PARK SDC COMMITTEE RECOMMENDATION

RE: **Park SDC Qualified Public Improvement Review Committee Recommendation related to AM/DRI LLC request for \$7,004,475 in Parks and Recreation SDC Credits pursuant to building permits 19-238761 and 19-238765, and associated future permits for Blocks 44 and 45.**

ALAMO MANHATTAN BLOCKS - GREENWAY

- N Representative Accessway (Lane Accessway)

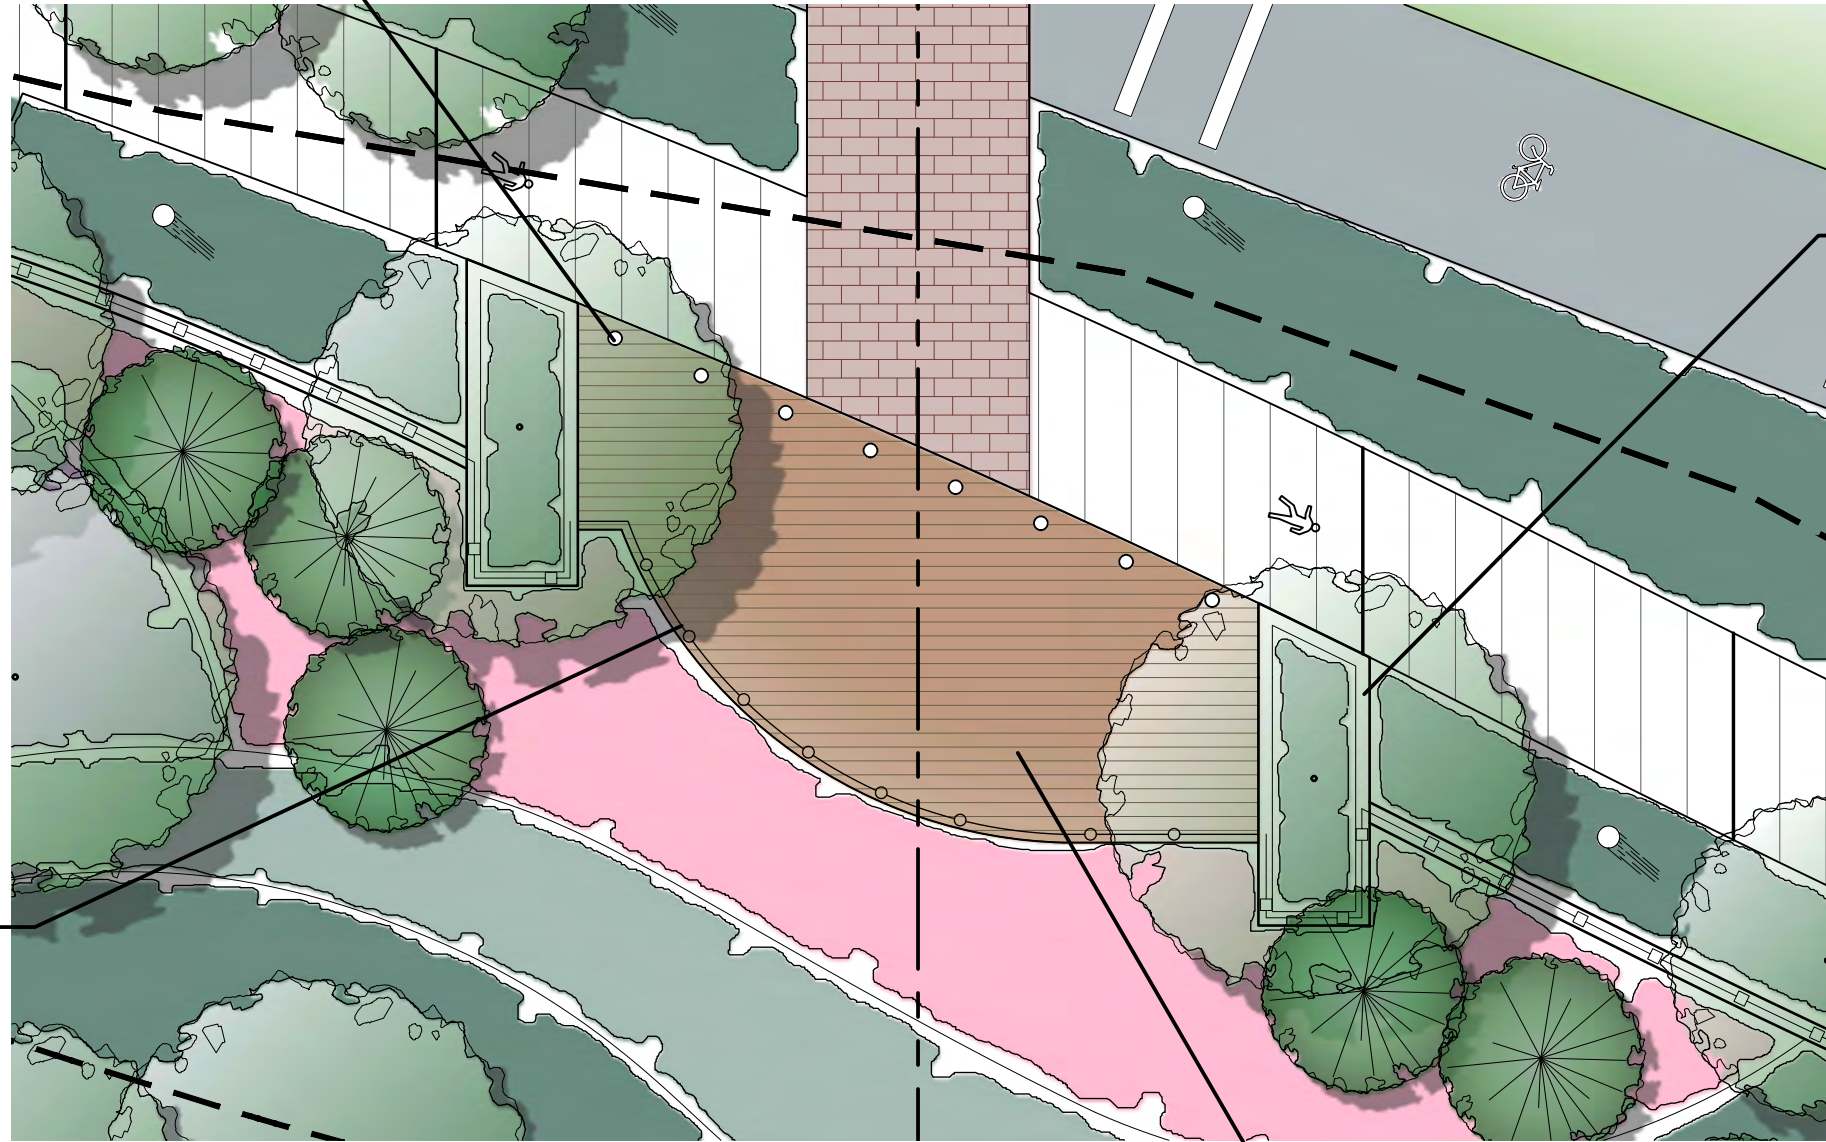
Criterion 1: Whether the proposed improvement "increases the capacity of the City's Parks and Recreation System." Staff finds that the improvement will not increase the capacity of the City's Parks and Recreation System. The three accessways are required for motor vehicle and public access as a condition of the development approval and, in staff's view, are not part of the park system but, rather, part of the City's transportation infrastructure, as outlined in the South Waterfront District Street Plan, amended most recently in 2016. They are part of the property owner's responsibility to provide access to the development.

- 1) Staff finds that being included in the approved Land Use proposal satisfies the requirement to be a condition of development approval.
- 2) Staff finds that the accessways do not satisfy the requirement to be part of the plan and list adopted pursuant to ORS 223.309. Accessways to a trail are not regularly provided as part of the park system. These three accessways are not on the Park SDC-CIP list.

EXHIBIT E- UNIQUE CUSTOM FURNISHINGS
IN THE GREENWAY

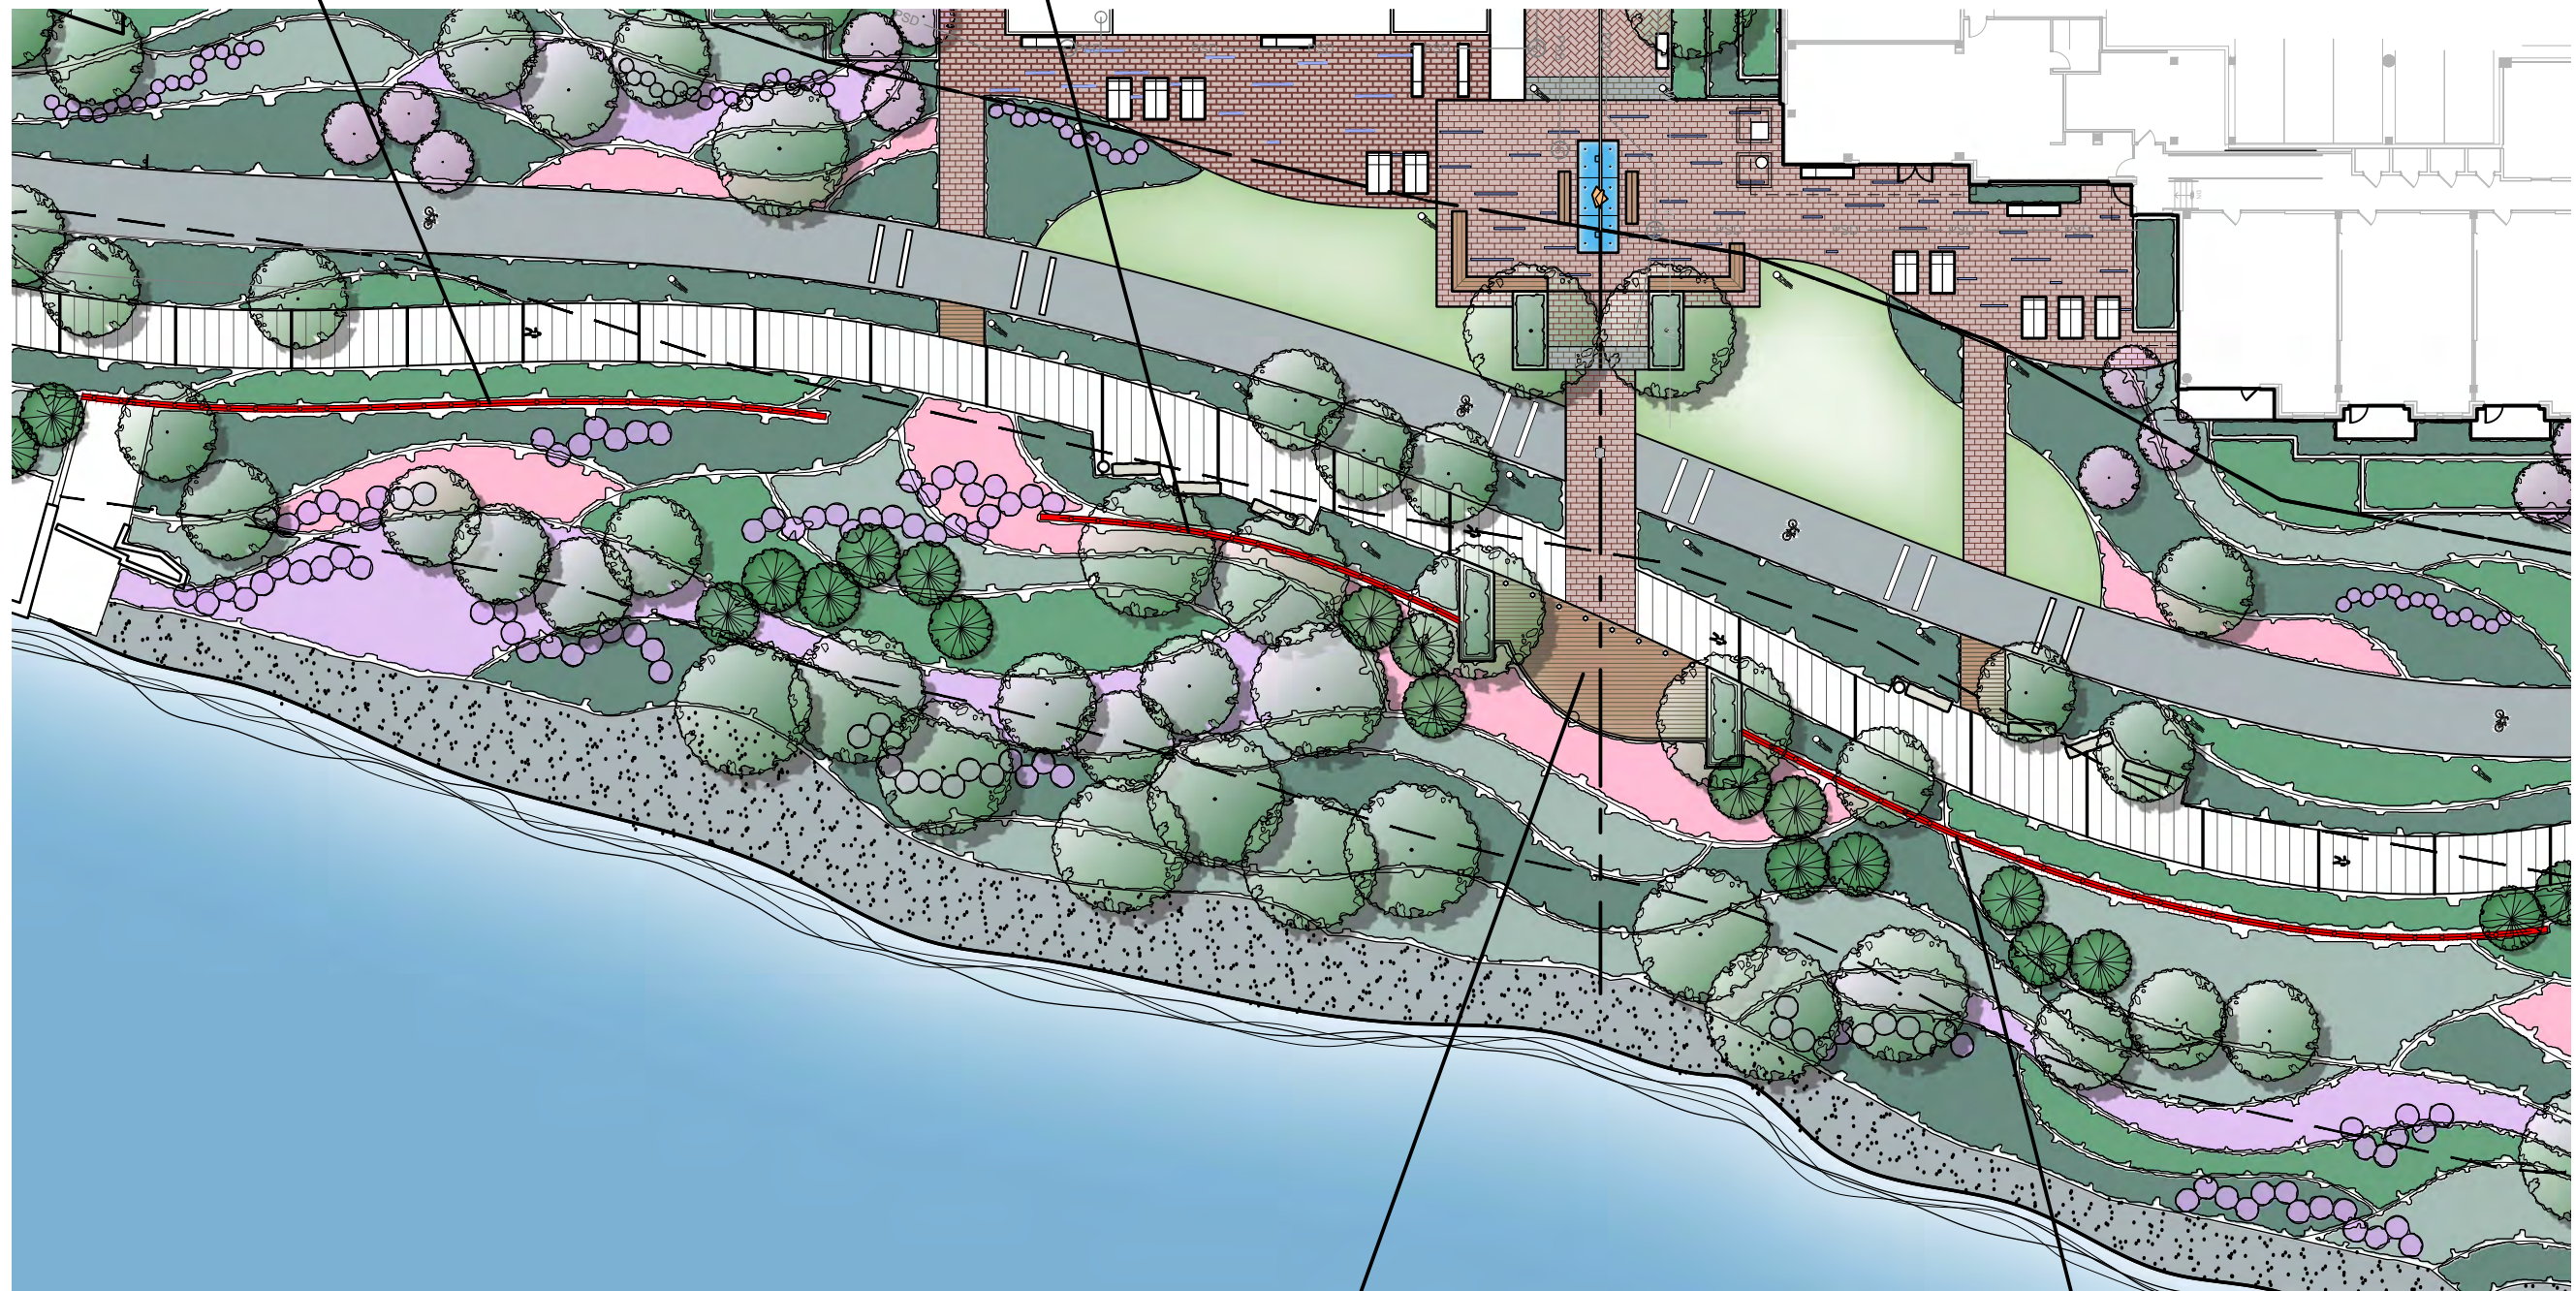
5. Greenway Items: A5. Greenway Furnishings
Summary: All six Committee members recommend approval of this PSDC Credit Request. The PP&R Staff Report also recommends approval of this PSDC Credit request.

A5, A6, A7 Greenway Furnishings, Additional Landscaping, and Retaining Wall: In the Bureau's opinion, each of these features would add capacity and qualify. These would all typically be included in the South Waterfront (SWF) Greenway trail and are suggested in the SWF Greenway Design Guidelines. The Bureau recommends credits for these improvements.

The greenway furnishings will be of benefit to park users and the 2004 South Waterfront Greenway (SWG) Development Plan envisions such furnishings along the Greenway, though the plan did not require them.

- 2) Staff finds that the greenway furnishings satisfy the requirement to be part of the plan and list adopted pursuant to ORS 223.309. Furnishings along a trail are typically included in trail development. The trail is on the SDC-CIP list as part of the “South Waterfront Greenway South District SOWA – Lane Street to River Forum Segment – South Stretch of Central District” project.
